BULLETIN

Subject: NCX-5 Balanced Modulator
Modification

Sales Bulletin: ES 65-1

NCX-5

PARTS TO BE ADDED DURING MOD

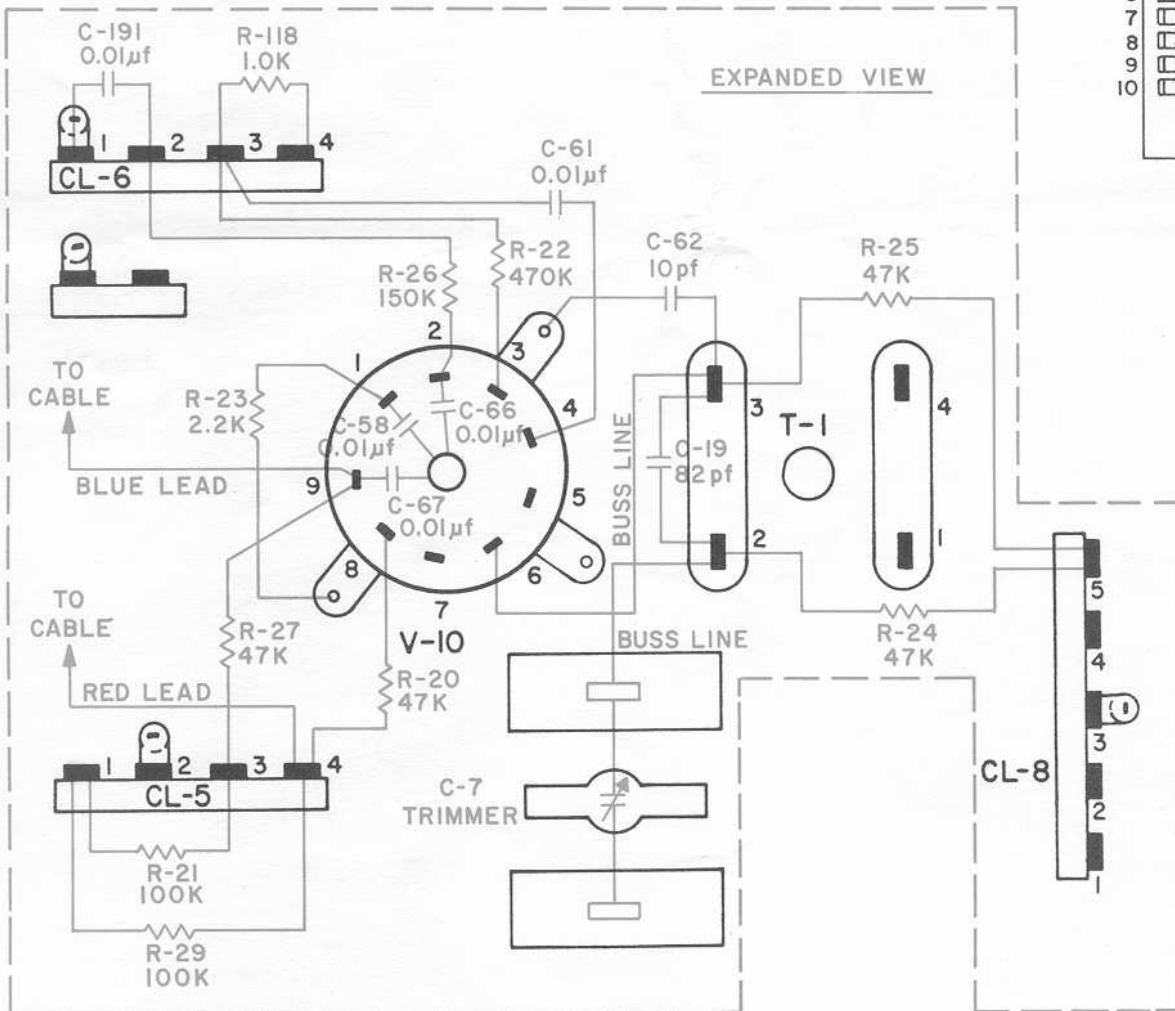
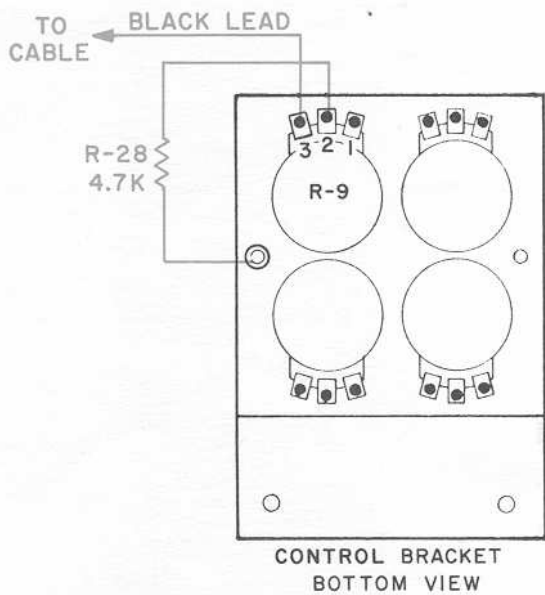
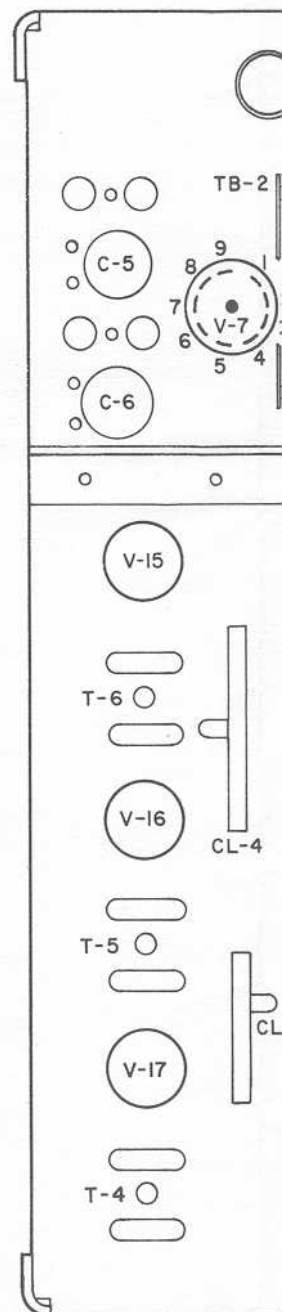
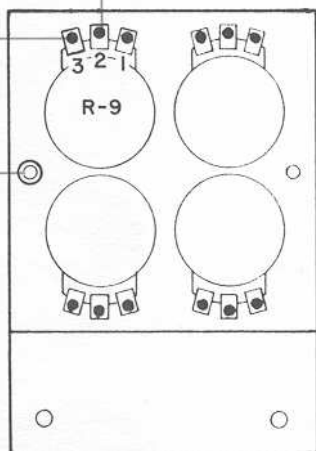
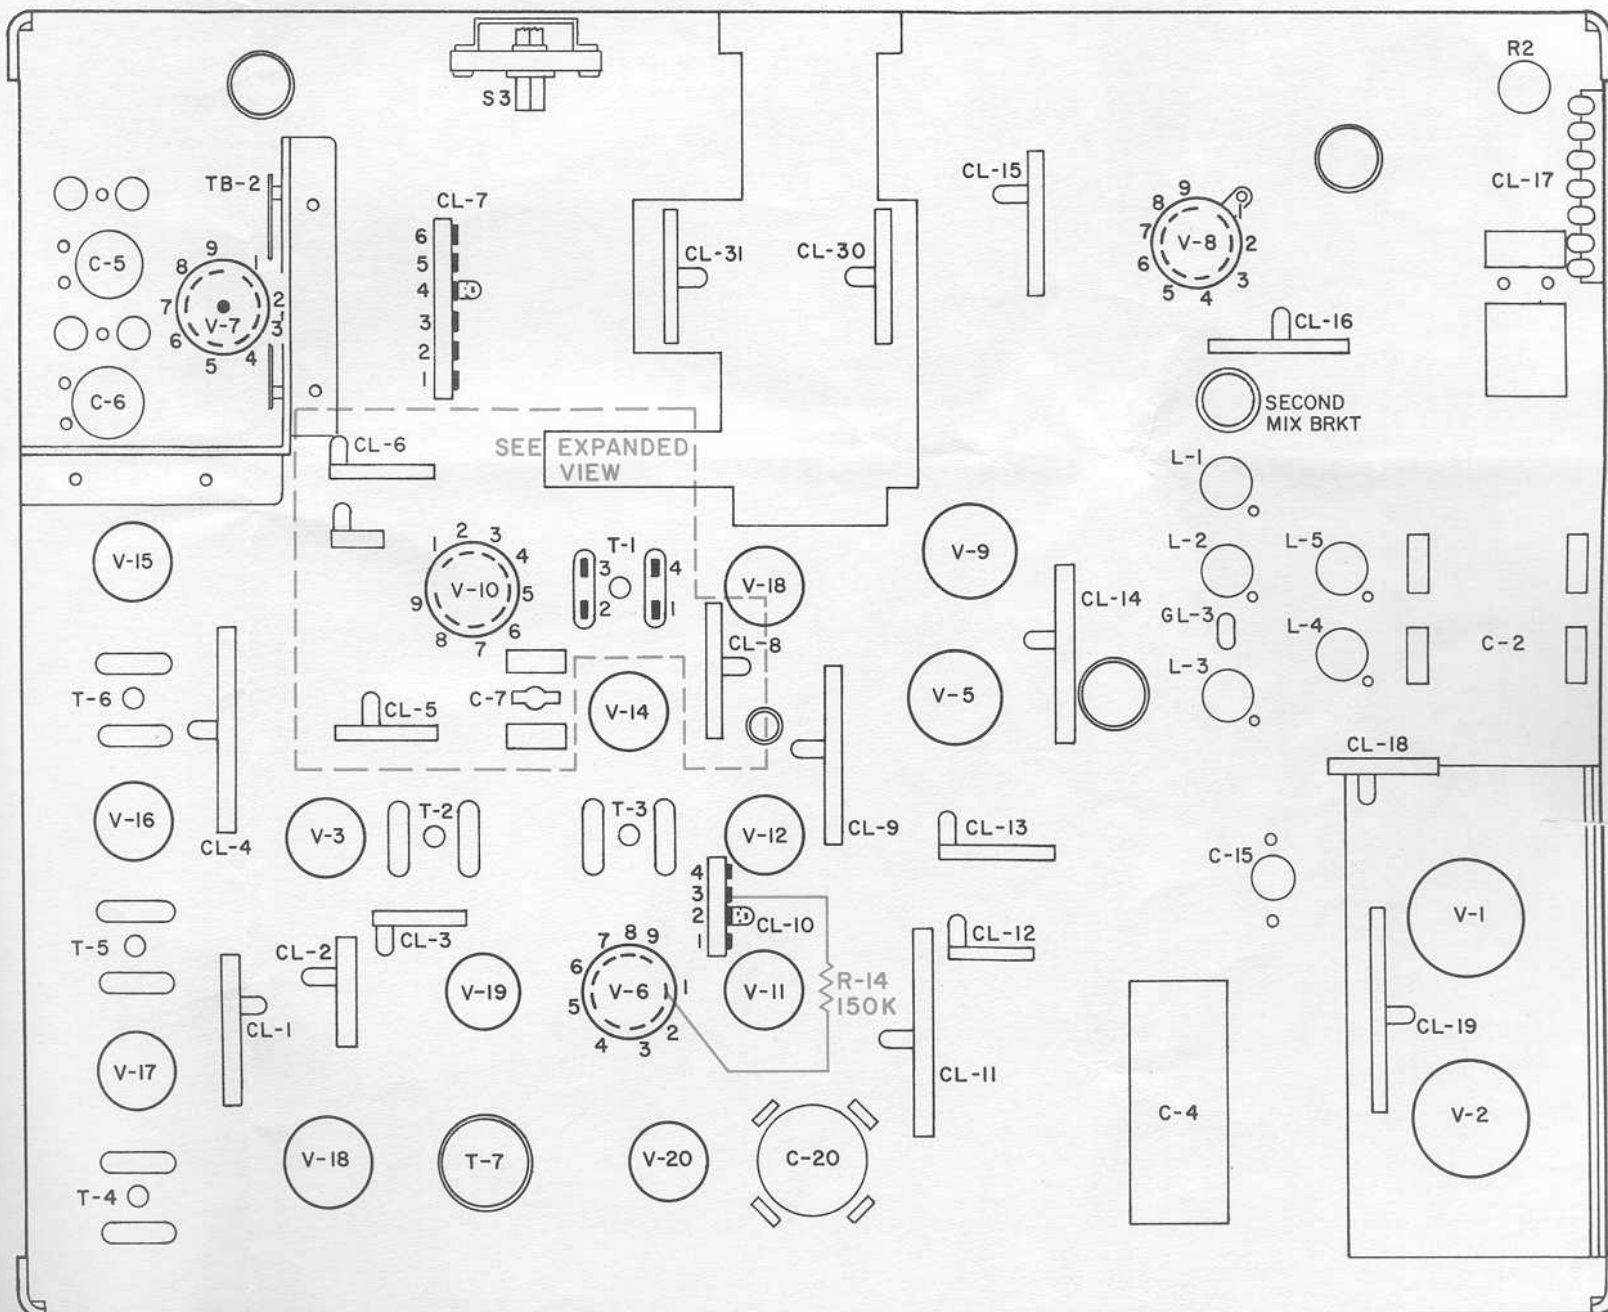
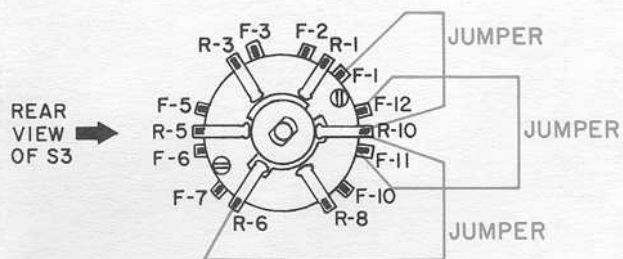
When following the modification procedure, close attention should be paid to the pictorials. First, read the step. Second, locate the part on the pictorial. (If adding a part, locate it on the "Add" pictorial, and if removing a part, locate it on the "Omit" pictorial.) Third, locate this part in the set, and make the modification. Fourth, check off the step in the step-by-step instructions. The new schematic supplied with the balanced modulator kit is a partial NCX-5 schematic including all of the areas which are affected by the kit. Do not solder any connections until specifically directed to do so by the instructions. When removing components, leads may be clipped to facilitate removal and to prevent heat damage to remaining components.

DRIVE FALLS OFF AT HIGH END---15 METERS

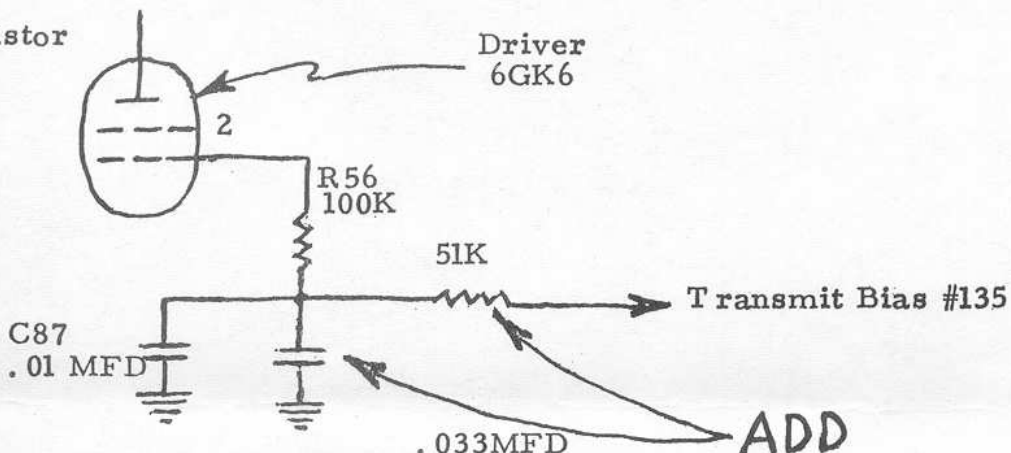
L-13 and associated wiring sets up a stray resonant trap which acts as a suck-out on 15 meters.

1. Disconnect the white coax lead (labelled #11), at 10 o'clock on the switch wafer section (S1-G) located between power amplifier cage and crystal mixer shield.
2. Reconnect the coax to the fourth (4th) unused terminal on S1-G, counting clockwise from the original terminal. This unused terminal is located at approximately 2 o'clock.
3. Connect a 100-ohm 1/2 watt resistor between the two terminals of S1-G mentioned above.

CARRIER LEAKAGE
(after bal. mod. installation)

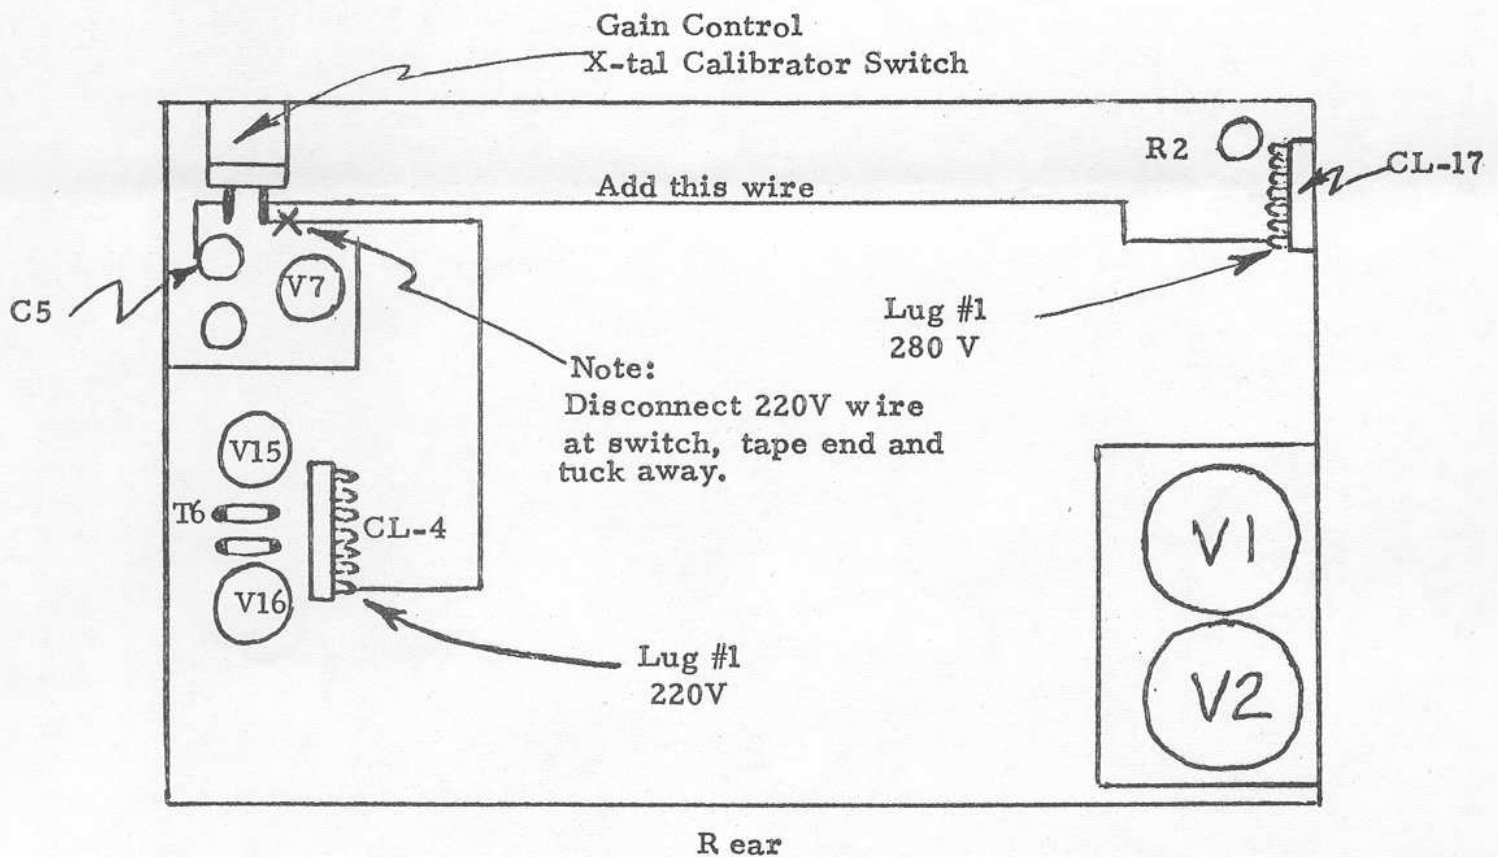
This is usually due to faulty lead dress. Solution: Keep all leads as short as possible and dress close to chassis.
